ASHLAND PLANNING DEPARTMENT
PRE-APPLICATION CONFERENCE
COMMENT SHEET
December 20, 2023

SITE: 348 N Main St
APPLICANT: Laura Sainz
REQUEST: Site Design Review for 6th Unit

Site Review:

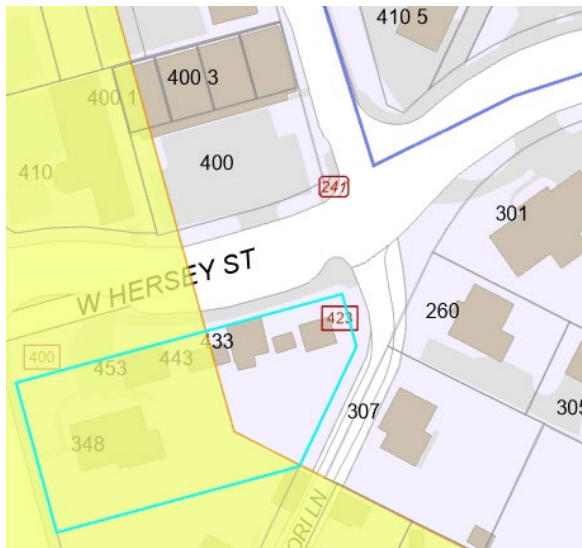
For multifamily residential developments, careful design considerations must be made to assure that the development is compatible with the surrounding neighborhood. Site Design Review criteria are largely design-focused, and all newly proposed structures should address building location and orientation as well as historic standards. Site Design Review standards and criteria for Residential Development would need to be met as outlined in Chapter 18.4.2.030. In addition, Historic District Design Standards in Chapter 18.4.2.050 would apply within the boundary of the Skidmore Historic District (shown on map below in yellow).
